CERTIFICATE OF APPROPRIATENESS PLACARD

Alter exterior stairs; remove portion of canopy

401 E Whitaker Mill Rd

COA-0133-2019

~~Exterior stair 5~~

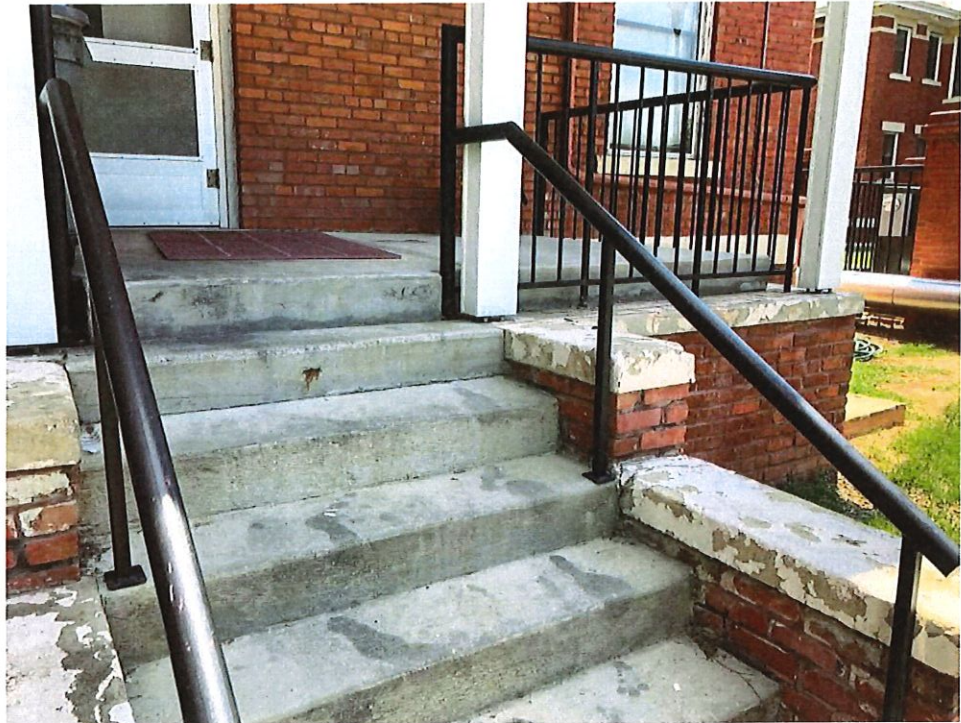
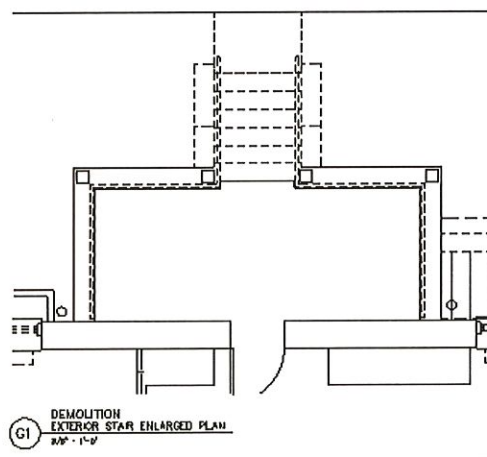
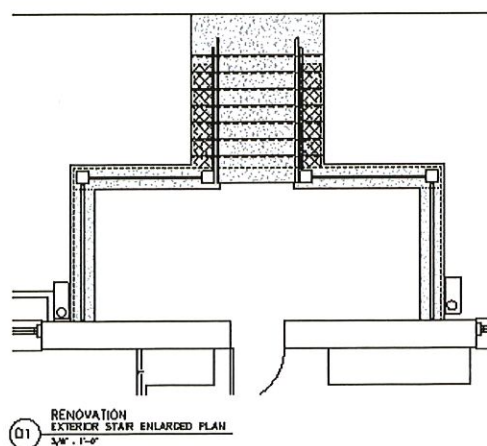
After reviewing the materials and looking at the photographs, we have concluded that the entryway at the rear (#5 on page 3) and on the side (#10 on page 3) are too visible and substantial to be approved by staff. We ask that those two alterations be added to the major work filed for the cupola. If you're amenable to that change, I'll make a note in the application and move forward with approving the alterations for the remaining entryways.

This stair removed & included in major work COA COA-0134-2019

Thanks for reviewing the application. As suggested, I'll add the stair #5 and #10 renovation work to the major work application.

Exterior stair 6

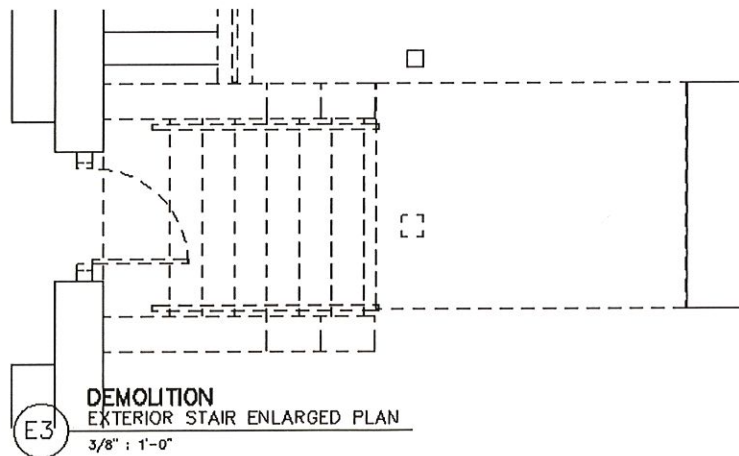
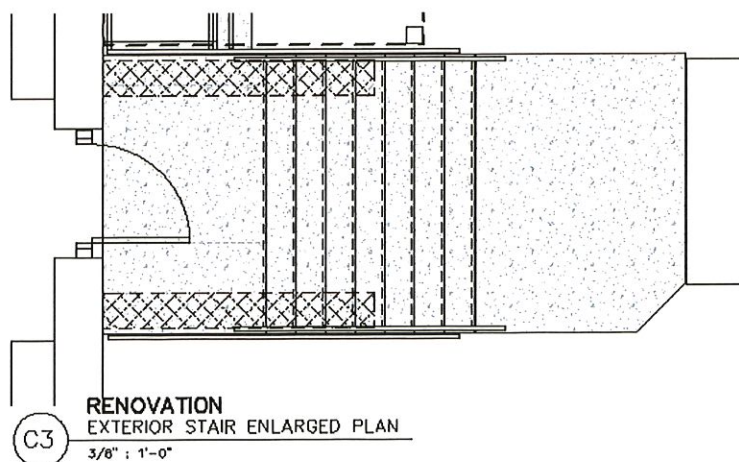
Removing that canopy shouldn't be an issue at all. Can you send a photo that shows the full canopy or are you just removing the portion that's over the stairs? If you're just removing the part that's over the stairs, what will be the final appearance of the altered edge of the canopy?

majority of the entryways. I had one clarifying question – on page 10 (exterior stair 6), are you proposing to remove the entryway roof or just the supporting post?

Please see below a few additional photos of the wood canopy. We're intending to remove just the portion above the door/exterior stair and keep the remaining, which is protecting an existing stair access to the basement. As shown below, there is an existing white gable on the right side of the door which will remain and become the canopy side. I hope this clarifies your questions.

Regarding stair #6, page 10 – yes, our intention is to remove the wood post located in front of the stair and the portion of the canopy located above the door. The canopy is not part of the original design and interferes with the egress path.
